UNITED STATES PATENT AND TRADEMARK OFFICE

APPLICATION NO.	FILING DATE	FIRST NAMED INVENTOR	ATTORNEY DOCKET NO.	CONFIRMATION NO.
10/822,706	04/13/2004	Tomotoshi Senoh	086142-0629	2928
22428	7590	12/20/2005	EXAMINER	
FOLEY AND LARDNER LLP SUITE 500 3000 K STREET NW WASHINGTON, DC 20007			KAYES, SEAN PHILLIP	
			ART UNIT	PAPER NUMBER
			2841

Office Action Summary	Application No. 10/822,706	Applicant(s) SENOH ET AL.	
	Examiner Sean Kayes	Art Unit 2841

DETAILED ACTION

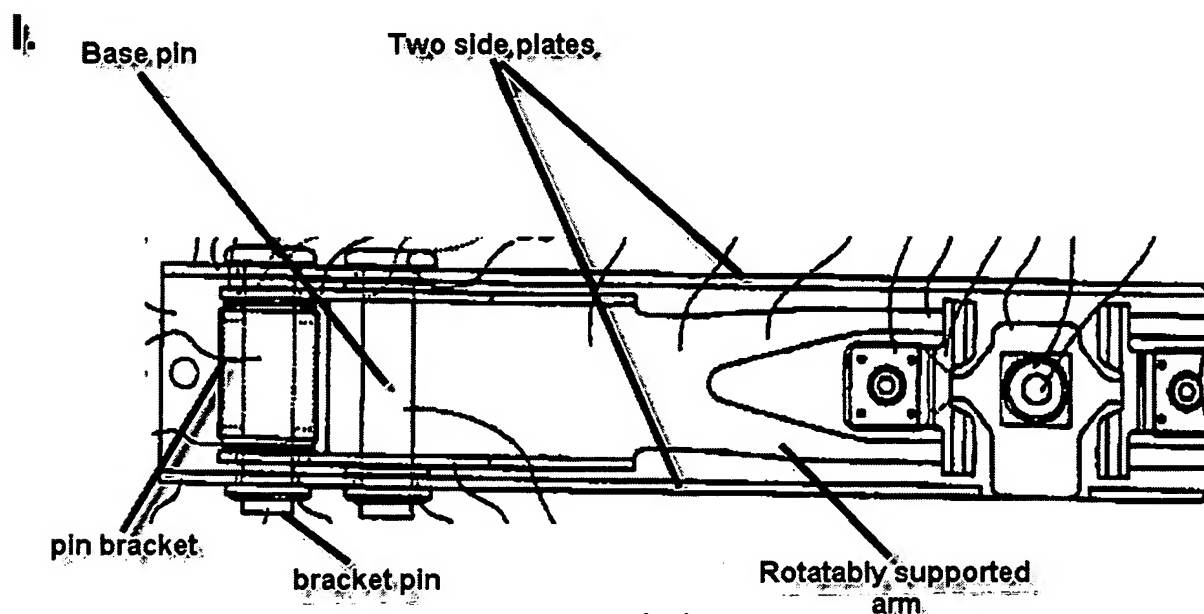
11. With respect to claim 7, Aoki discloses a device for measuring seat weight including the weight of an occupant sitting on the seat, the device comprising: a base having two side plates (see picture I. provided below); an arm rotatably supported by and interdisposed between the side plates of the base via a base pin (see picture I. provided below, and item 31 figure 4); a pin bracket in communication with the arm via a bracket pin and further in communication with the seat (see picture below, and items 25 and 27 figure 4); a load sensor in communication with the arm; and wherein the pin bracket is located between the base pin and the load sensor. Aoki does not explicitly

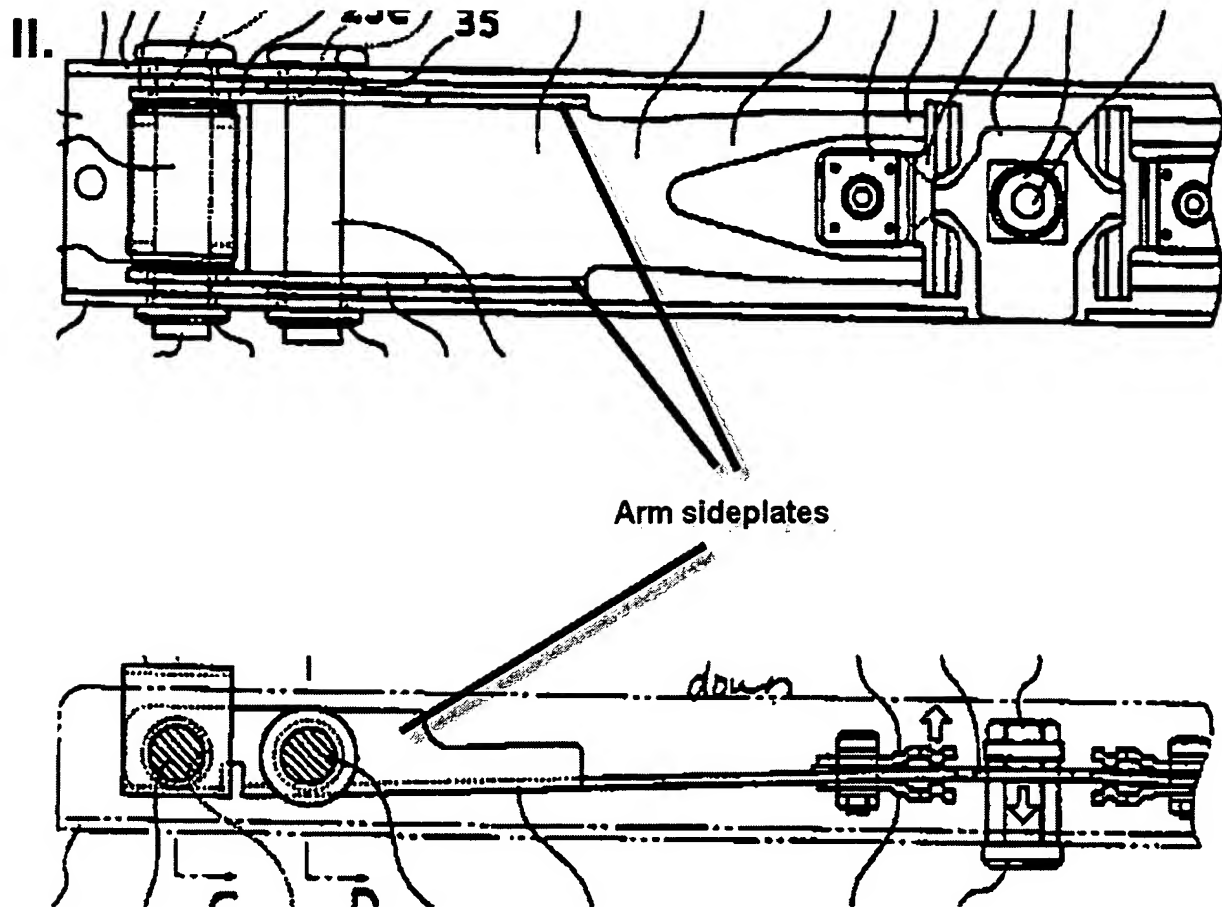
14. With respect to claim 10, Aoki discloses the device of claim 7 (see 103 rejection above), wherein the pin bracket of the present invention is rotatably supported by the base pin ((figure 4 and column 2 lines 25-30 and see picture I. provided above.)
